Urban Design Review Panel Report 1822 Bank Street

RE: Urban Design Review Panel Report

Official Plan Amendment, Zoning By-law Amendment, and Plan of Subdivision Applications 1822 Bank Street

Enclosed, please find responses to the Urban Design Review Panel's comments provided on March 11, 2024, regarding the Official Plan Amendment and Zoning By-law Amendment applications for the property municipally known as 1822 Bank Street, Ottawa.

23-11-13 PROJECT: DRAWING NO. A1.00

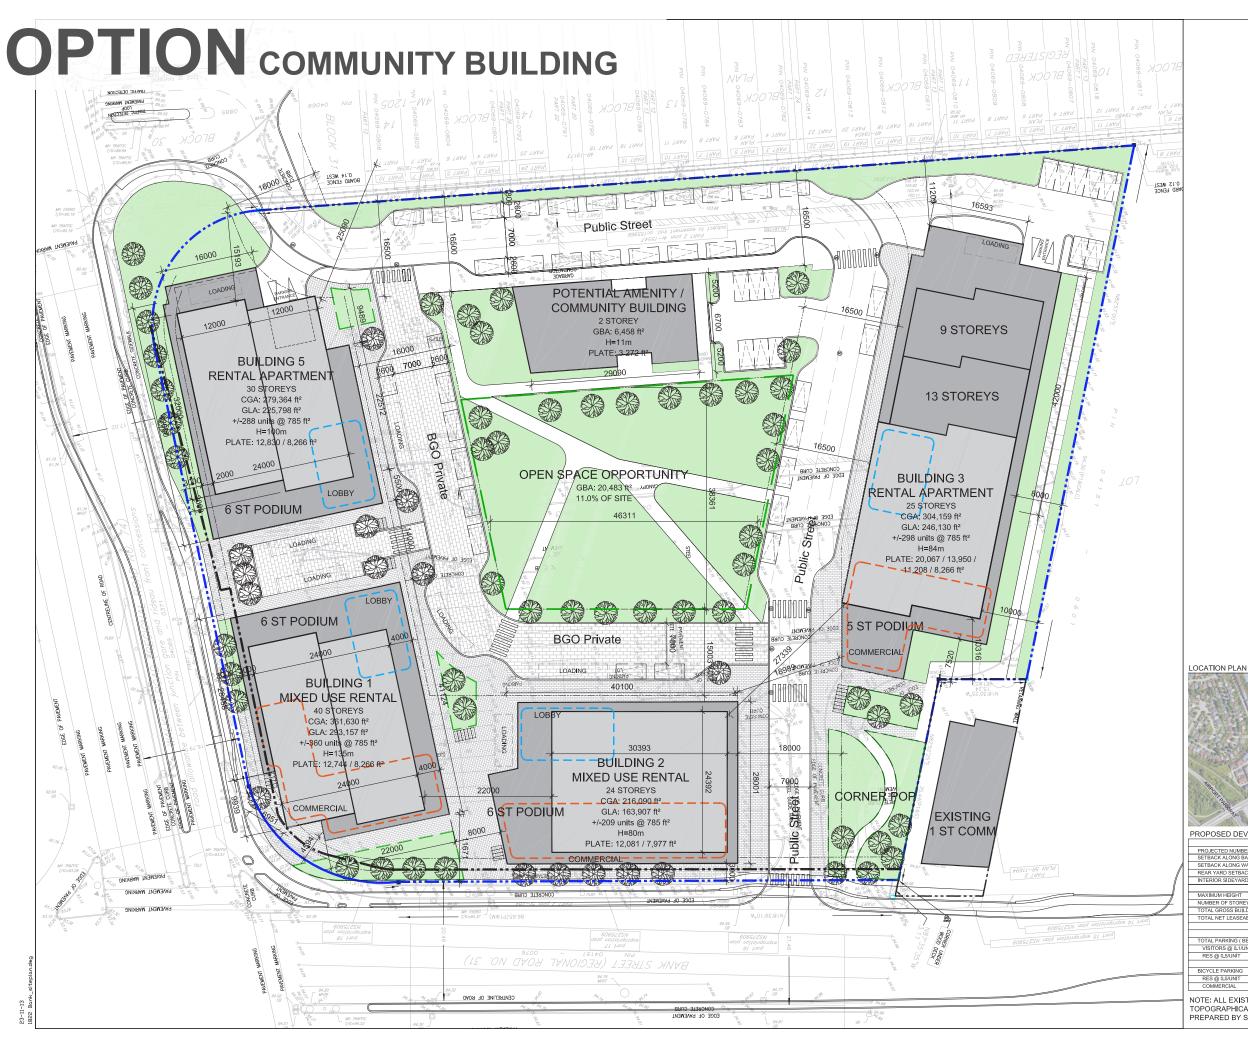
4. The Panel has some concerns with the heights of Building 5 and Building 2, with Building 5's height appearing too tall and having a negative effect on the residential neighbourhood to the west and the park, and Building 2 appearing capable of taking on more height if necessary. Consider reallocating the heights and densities of these two buildings.

5. The Panel suggests potentially rotating Building 1 on the corner of Walkley Road and Bank Street to have its longer frontage facing along Bank Street rather than along Walkley Road.

14. The Panel questions whether the location of the loading and servicing for Building 5 is appropriate. More consideration ought to be given to that south-western corner and how it connects with the access off Walkley Road, from both the vehicle and pedestrian perspectives.

Response: The height of Building 5 at the southwest corner (now referred to as Building 1) has been reduced in height to 24 floors to provide a more sensitive transition to the adjacent neighbourhood to the west. Additional height has been added to Buildings 2 and 3 (corner of Bank and Walkley and facing Bank Street mid block) to shift the development density away from the low-rise neighbourhoods.

Response: The applicant explored this option and found that it compromised the separation distance between buildings facing Bank Street. However, the podium of this building (Building 1) has been reshaped to better frame the proposed POPs and provide a better relationship to Bank Street.

Response: The loading and servicing for Building 1 (formerly Building 5) has been relocated away from the intersection allowing for an improved POPs anchoring the corner. Additionally, a secondary building entrance has been added to face the intersection.

SUN SHADOWS EQUINOX

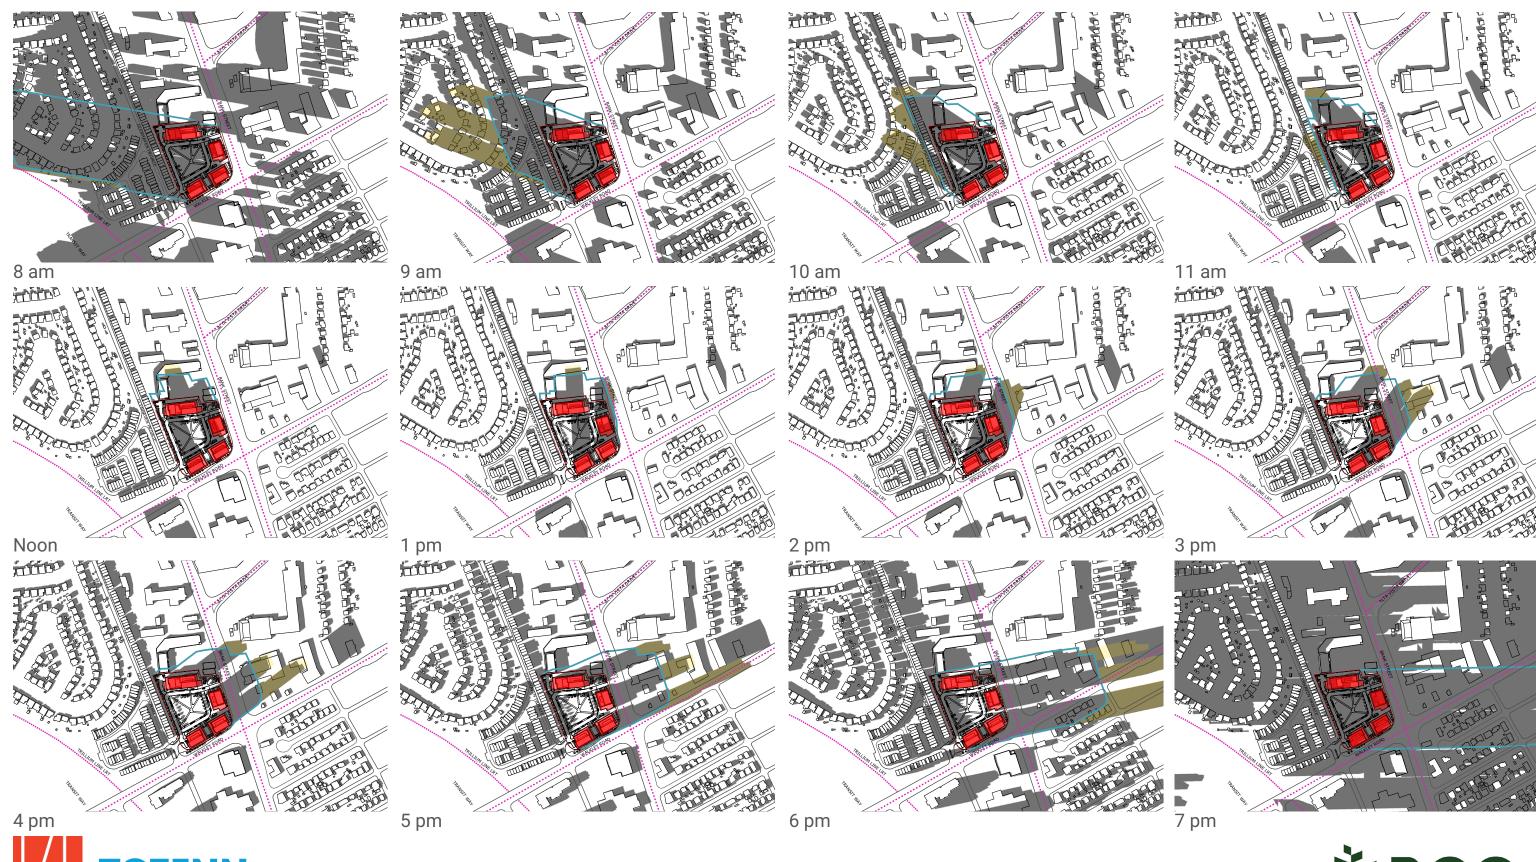
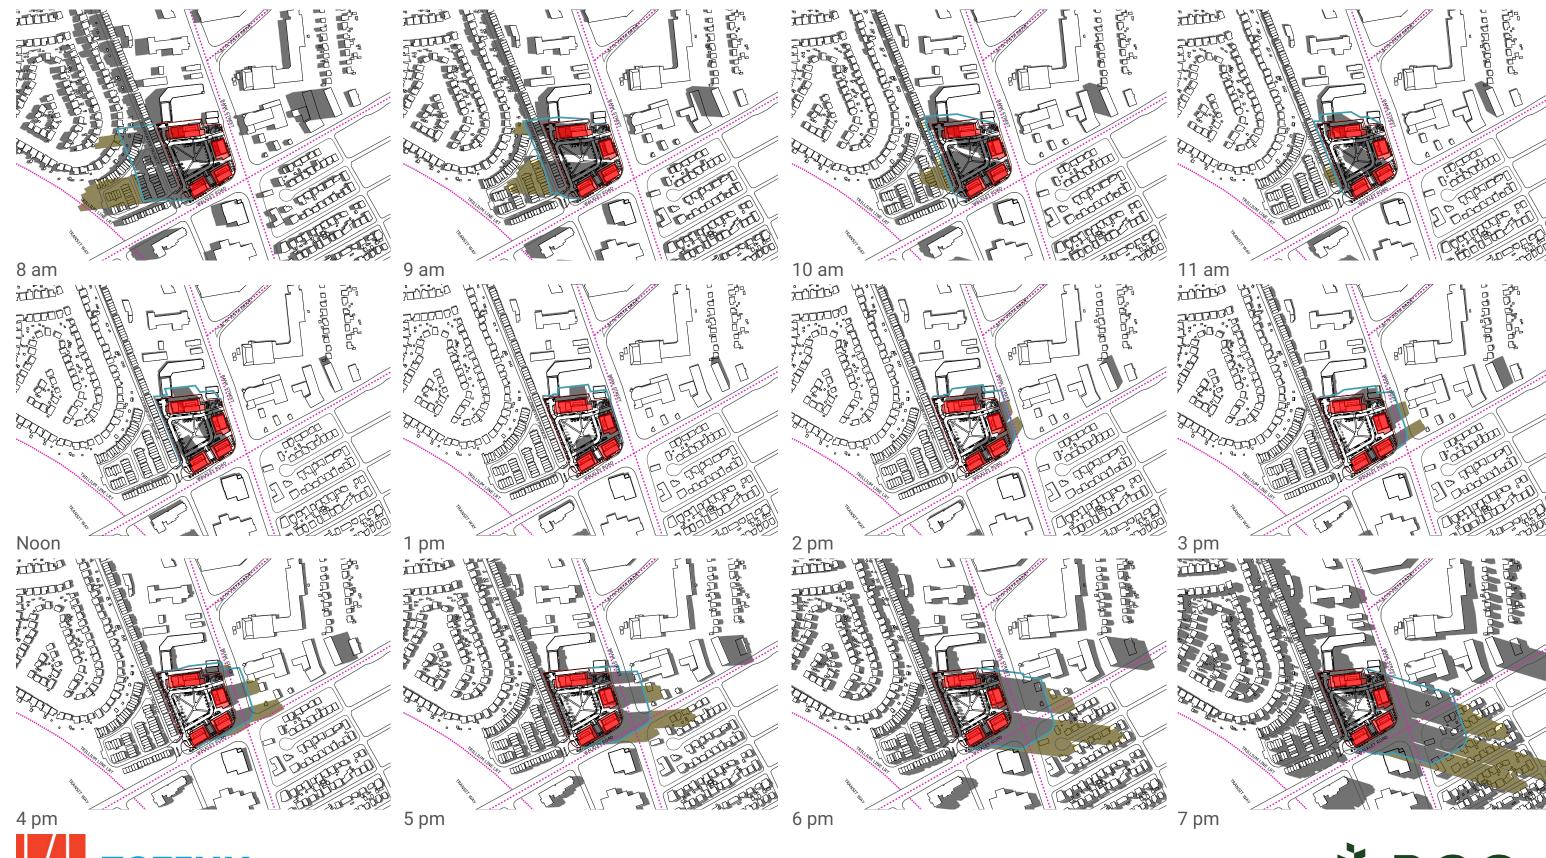
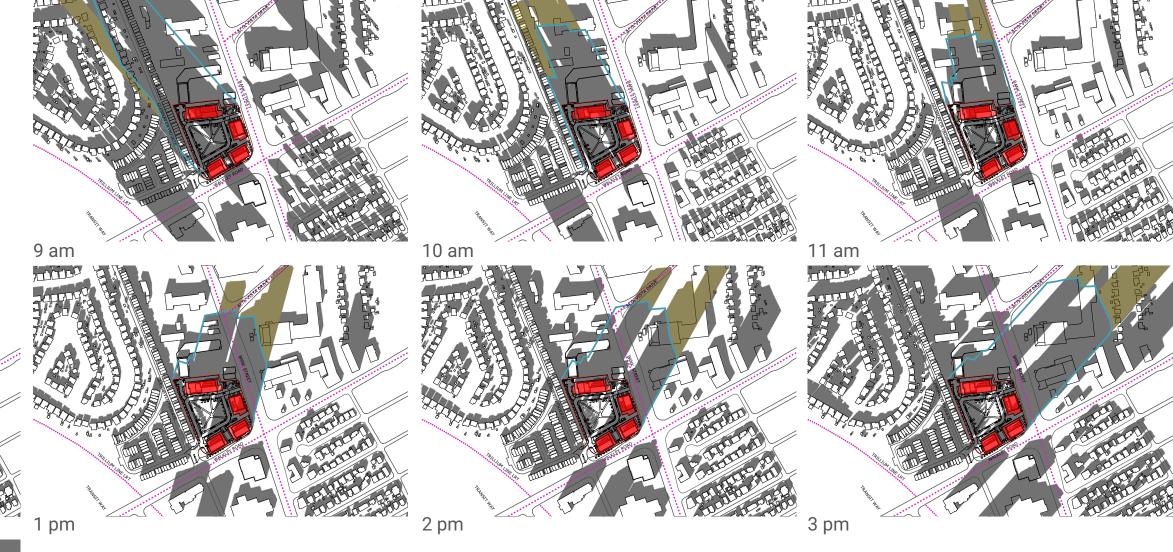
29. The Panel recommends Building 5 on the south-west corner on the site be reduced in height, and an alternate building mass with a lower height explored, as it has the most negative impact on the proposed park as well as on the established single-family residential neighbourhood to the west. Consider giving the park more ingredients for success by reducing long shadows over park space.

Response: Building 1 (formerly Building 5) has been reduced in height to 24 storeys to provide a better transition to the low-rise neighbourhood to the west. This change also makes a margin difference in shadowing on the parking in the late morning to noon period.
